Access Compliance Report

Public Rights-of-Way (Curb Ramps)

Intersection ID: N/A	Main Street: HARDING_PL	Cross Street: N/A	Location: SW
ADA ID: 4ED6E7FD7276	Ramp Type: PerpDiag	Initial Pass/Fail: Fail	Overall Compliance: No
		Severity Score: 47.5

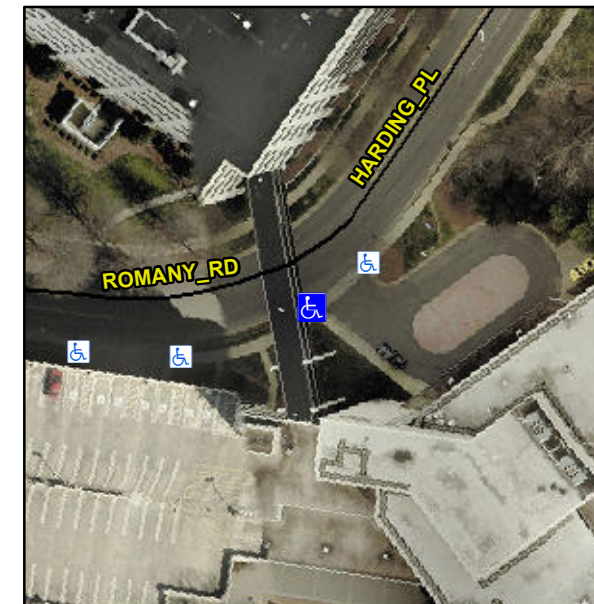
Not Found, R304.5.1, R304.2.2

Compliance	Description	Data	Compliance	Description	Data
N/A	Ramp Length (in)	48.0	No	Ramp Slope (%)	8.4
No	Ramp Width (in)	25.0	Yes	Ramp XSlope (%)	1.1
N/A	Flare Type LT	N/A	N/A	Flare Type RT	N/A
N/A	Flare Slope LT (%)	N/A	N/A	Flare Slope RT (%)	N/A
N/A	Flare Traversable LT?	N/A	N/A	Flare Traversable RT?	N/A
N/A	Landing Length (in)	N/A	N/A	DWS Provided?	N/A
N/A	Landing Width (in)	N/A	N/A	DWS Contrast?	N/A
N/A	Landing Slope (%)	N/A	N/A	DWS Length (in)	N/A
N/A	Landing X Slope (%)	N/A	N/A	DWS Full Width?	N/A
N/A	Landing Curb? (Y/N)	N/A	N/A	DWS Offset (in)	N/A
N/A	Shared Landing?	N/A			
N/A	Gutter Ponding?	N/A	N/A	Gutter Slope (%)	N/A
N/A	Gutter Lip Ht (in)	N/A	N/A	Gutter X Slope (%)	N/A
N/A	Painted X Walk1?	No	N/A	Painted X Walk2?	No
	X Walk 1 Direction	To E		X Walk 2 Direction	To NW
N/A	X Walk 1 Width (in)	N/A	N/A	X Walk 2 Width (in)	N/A
	X Walk 1 Slope (%)	1.2		X Walk 2 Slope (%)	2.8
	X Walk 1 X Slope (%)	9.9		X Walk 2 X Slope (%)	3.5

Remove & Replace Curb Ramp With Two New Directional Ramps or Equivalent.
